VIRGINIA ELECTRIC AND POWER COMPANY
RICHMOND, VIRGINIA 23261

AMENDMENT TO OPERATING LICENSES DPR-32 AND DPR-37
SURRY POWER STATION UNITS NO. 1 AND NO. 2
PROPOSED TECHNICAL SPECIFICATIONS CHANGES

SAFETY EVALUATION (TOTAL PEAKING FACTOR) FOR SURRY UNIT NO. 1

PROPOSED TECHNICAL SPECIFICATION CHANGE

HOT CHANNEL FACTOR NORMALIZED

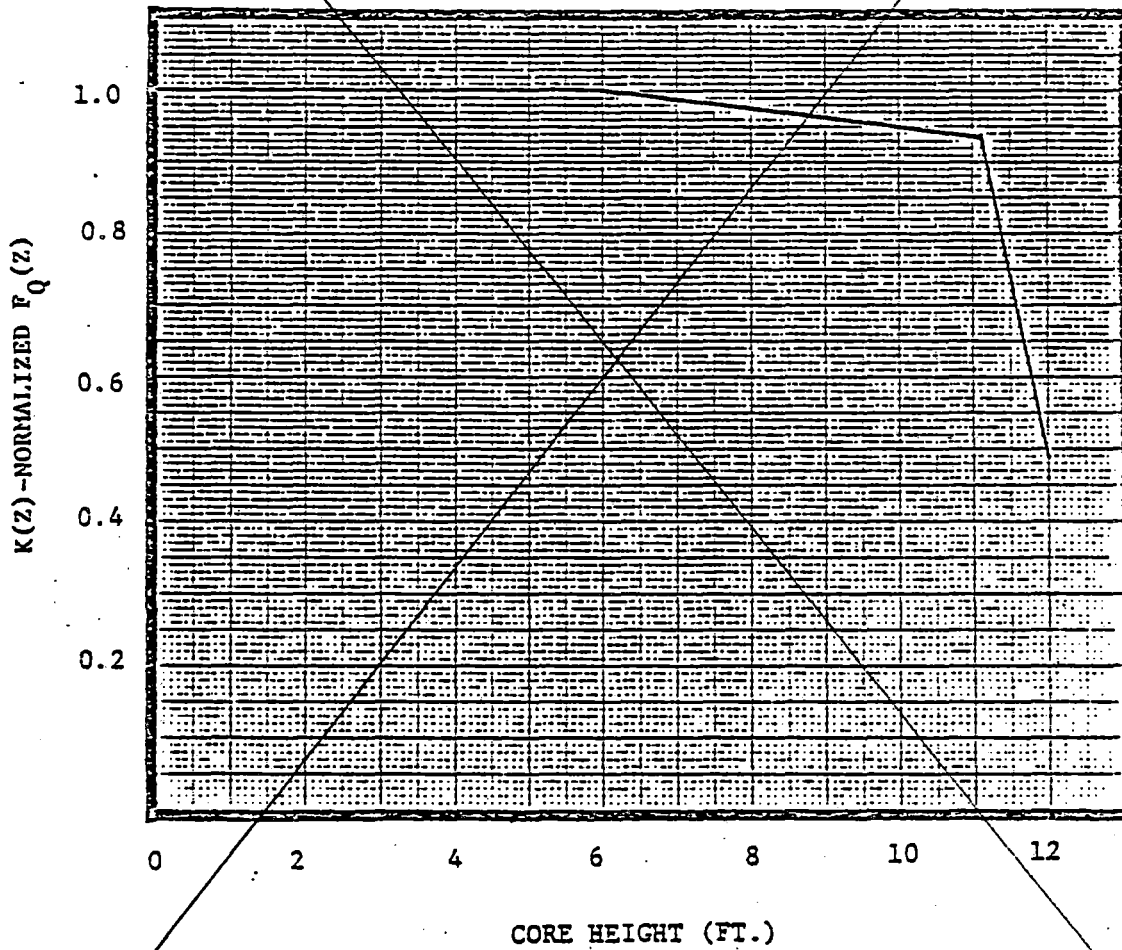
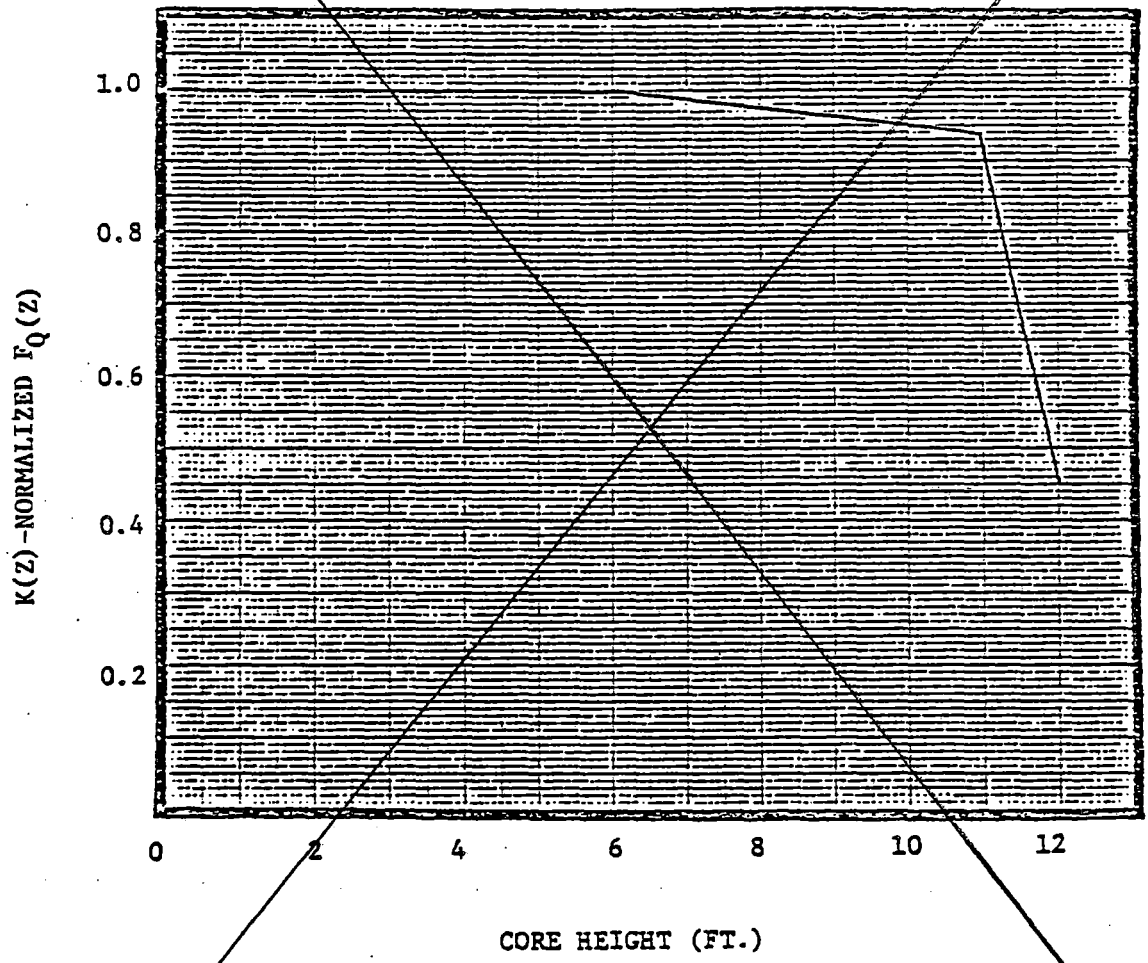
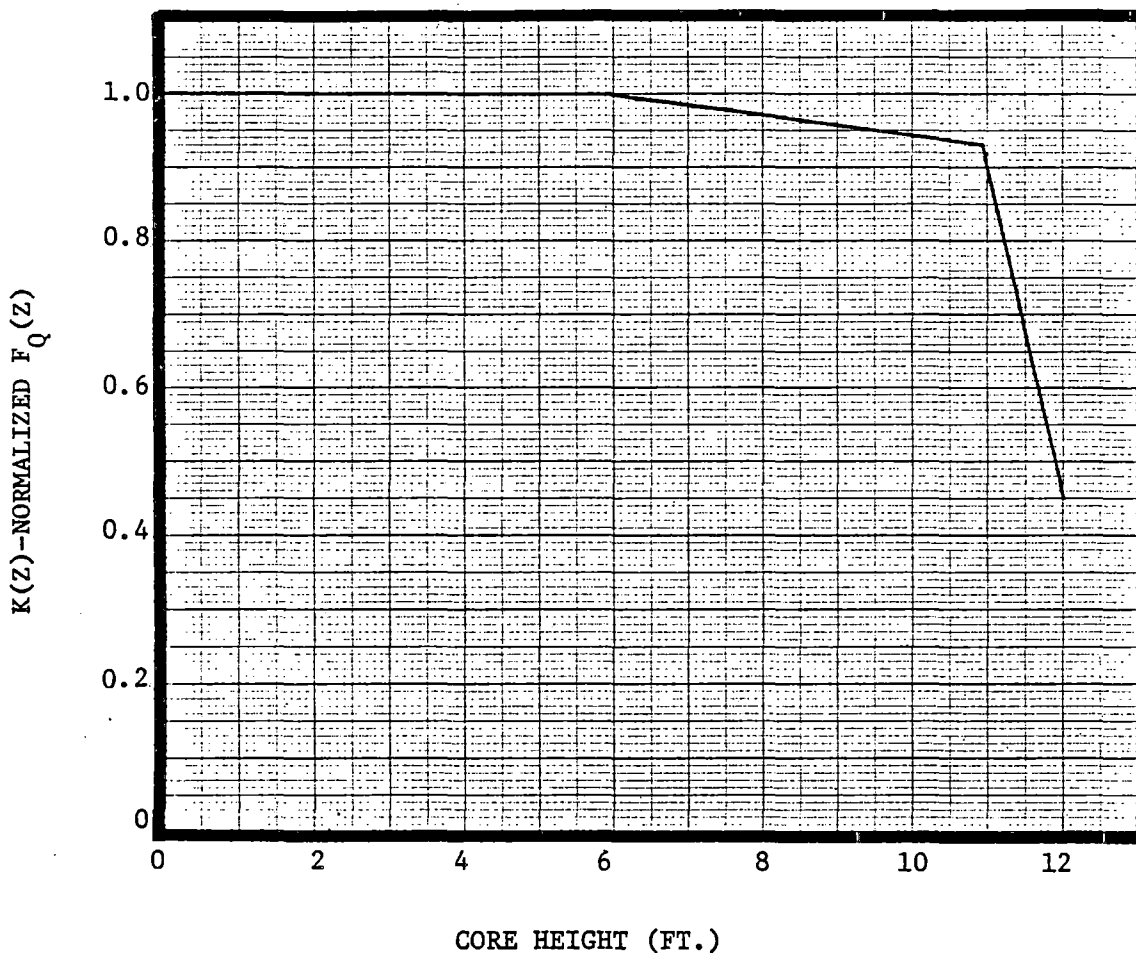
where P is the fraction of rated power at which the core is operating, K(Z) is the function given in TS Figure 3.12-8a for Unit 1 and Figure 3.12-8b for Unit 2, Z is the core height location of F_Q, and T(BU) is the interim thimble cell rod bow penalty on F_{ΔH}^N given in TS Figure 3.12-9.

SEE ATTACHED PAGE

HOT CHANNEL FACTOR NORMALIZED
OPERATING ENVELOPE
SURRY POWER STATION
UNIT NO. 2
SEE ATTACHED PAGE

SEE ATTACHED PAGE

TS FIGURE 3.12-10
~~5-9-79~~
(Unit 1)

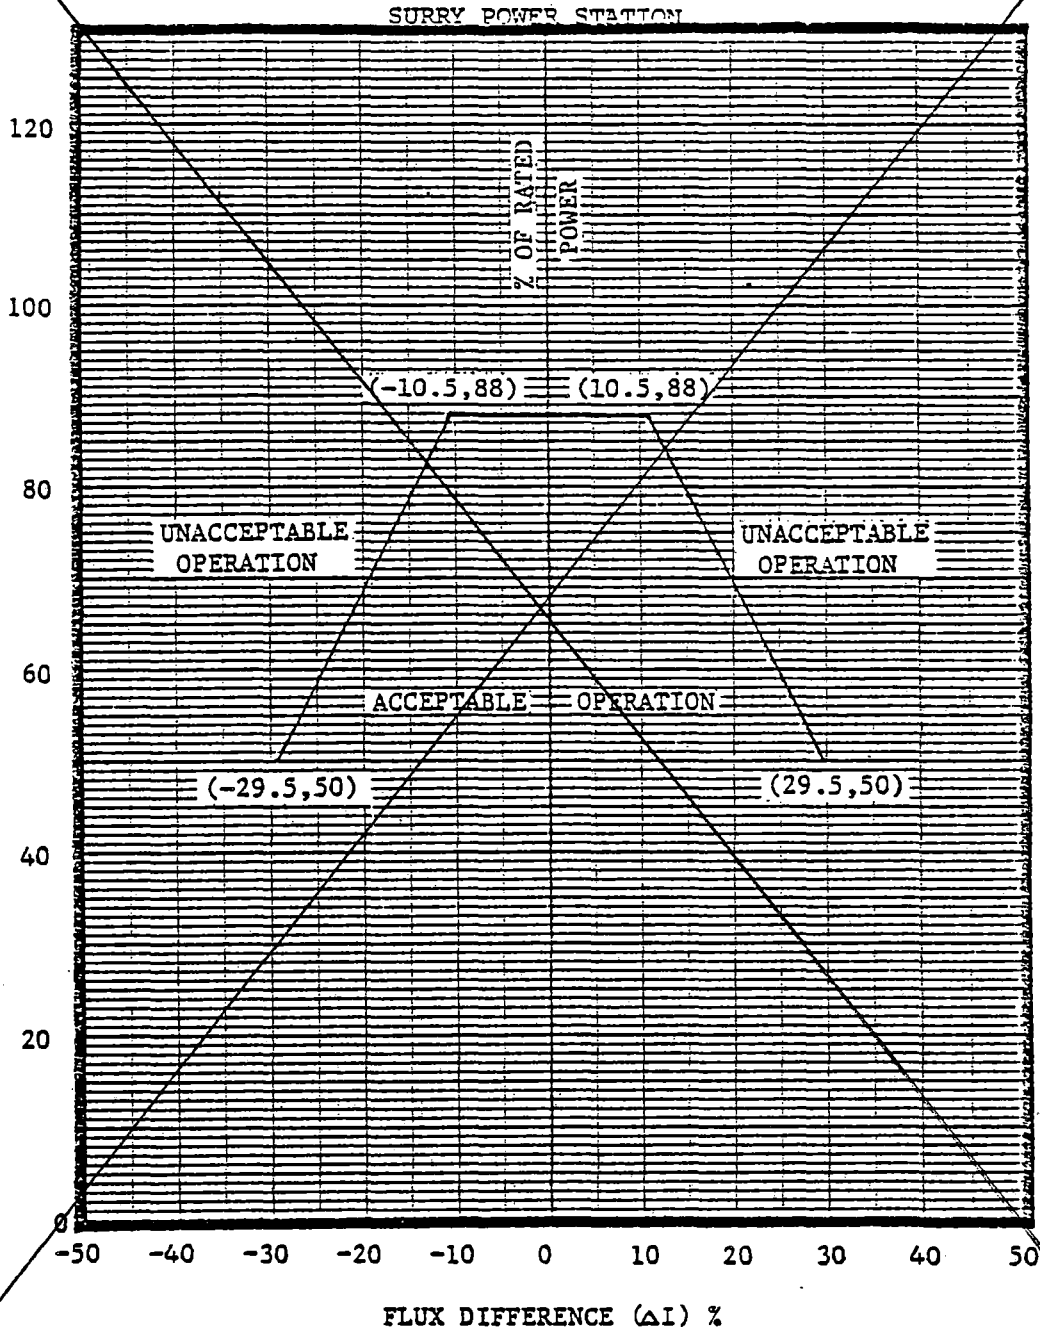
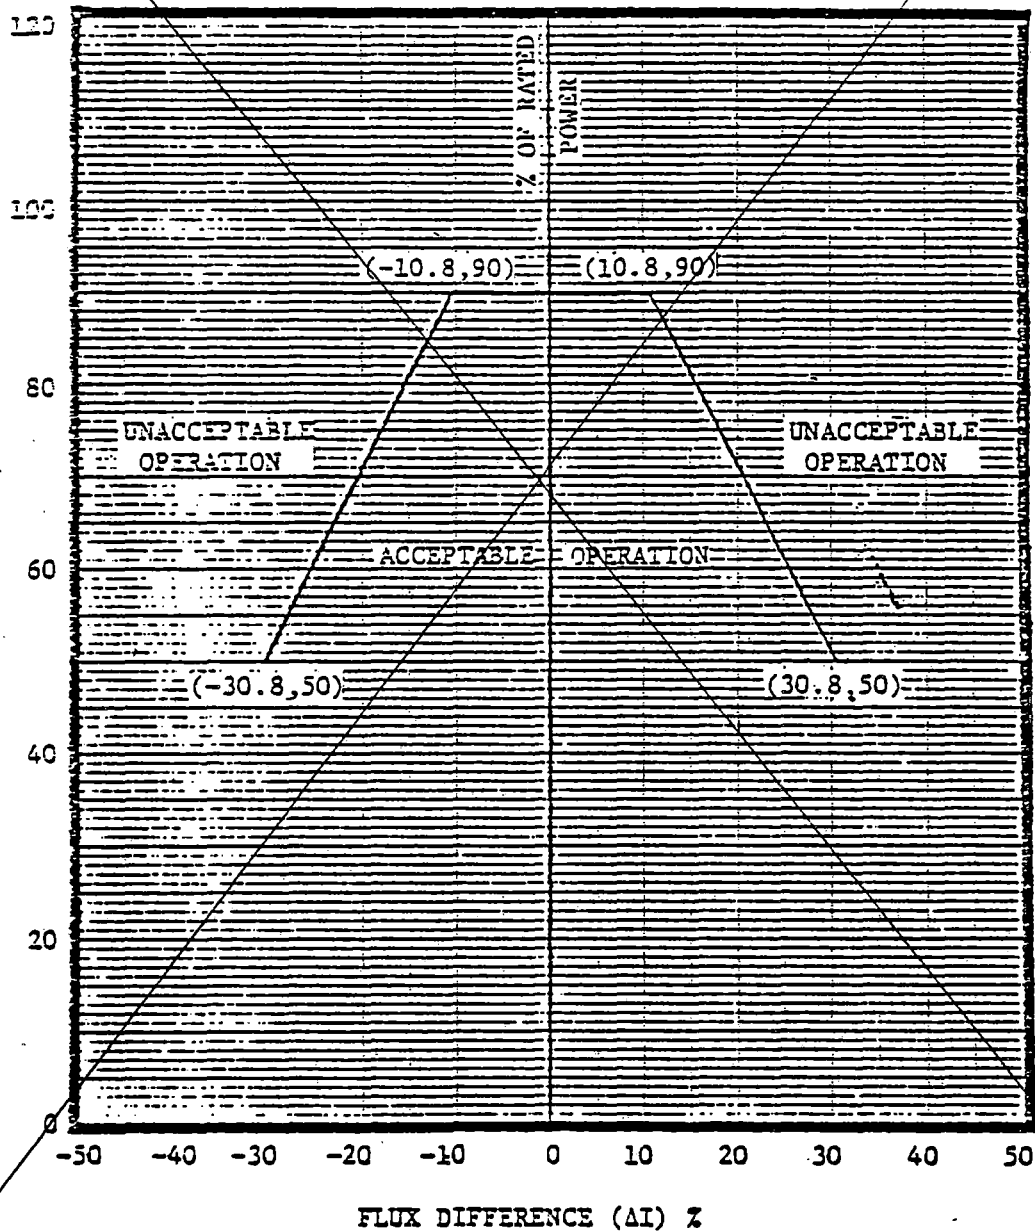
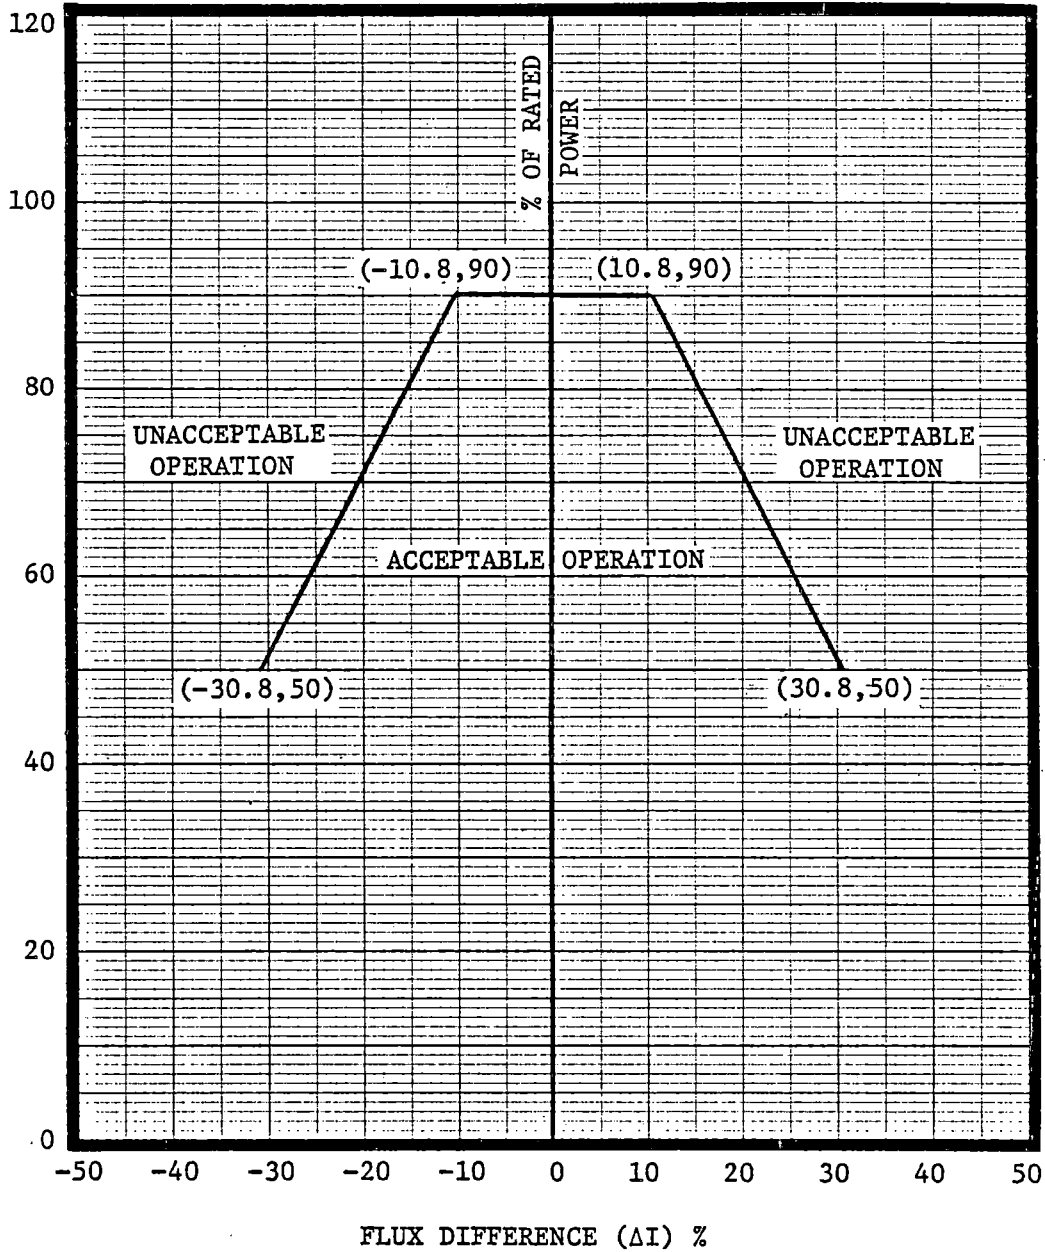
- b. At a power level no greater than 88 percent of rated power,
- (1) The indicated axial flux difference may deviate from its target band for a maximum of one hour (cumulative) in any 24-hour period provided the flux difference is within the limits shown on Figure 3.12-10.

SEE ATTACHED PAGE
